Access Compliance Report

Public Rights-of-Way

(Curb Ramps)

Intersection ID: 16126	Main Street: E_W_T_HARRIS_BV	Cross Street: IDLEWILD_RD	Location: NE
ADA ID: 5E00A5077FC6	Ramp Type: Perp	Initial Pass/Fail: Fail	Overall Compliance: No
Codes/Mitigation Info/Possible Solution		Field Measurements/Component Compliance	
Severity Score: 33.75

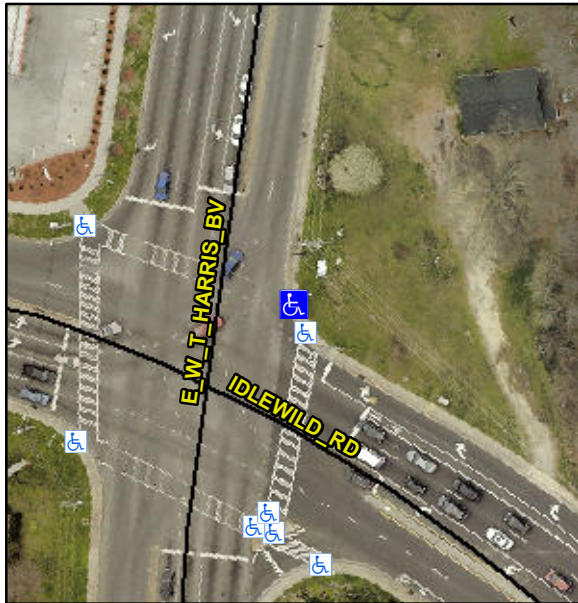
Remove & Replace Entire Ramp.

R304.5.1, R304.2.2

Compliance	Description	Data	Compliance	Description	Data
N/A	Ramp Length (in)	55.0	No	Ramp Slope (%)	13.9
No	Ramp Width (in)	40.0	Yes	Ramp XSlope (%)	0.9
N/A	Flare Type LT	N/A	N/A	Flare Type RT	N/A
N/A	Flare Slope LT (%)	N/A	N/A	Flare Slope RT (%)	N/A
N/A	Flare Traversable LT?	N/A	N/A	Flare Traversable RT?	N/A
N/A	Landing Length (in)	N/A	N/A	DWS Provided?	N/A
N/A	Landing Width (in)	N/A	N/A	DWS Contrast?	N/A
N/A	Landing Slope (%)	N/A	N/A	DWS Length (in)	N/A
N/A	Landing X Slope (%)	N/A	N/A	DWS Full Width?	N/A
N/A	Landing Curb? (Y/N)	N/A	N/A	DWS Offset (in)	N/A
N/A	Shared Landing?	N/A			
N/A	Gutter Ponding?	N/A	N/A	Gutter Slope (%)	N/A
N/A	Gutter Lip Ht (in)	N/A	N/A	Gutter X Slope (%)	N/A
N/A	Painted X Walk1?	No	N/A	Painted X Walk2?	N/A
	X Walk 1 Direction	To NW		X Walk 2 Direction	N/A
N/A	X Walk 1 Width (in)	N/A	N/A	X Walk 2 Width (in)	N/A
	X Walk 1 Slope (%)	2.1		X Walk 2 Slope (%)	N/A
	X Walk 1 X Slope (%)	2.7		X Walk 2 X Slope (%)	N/A
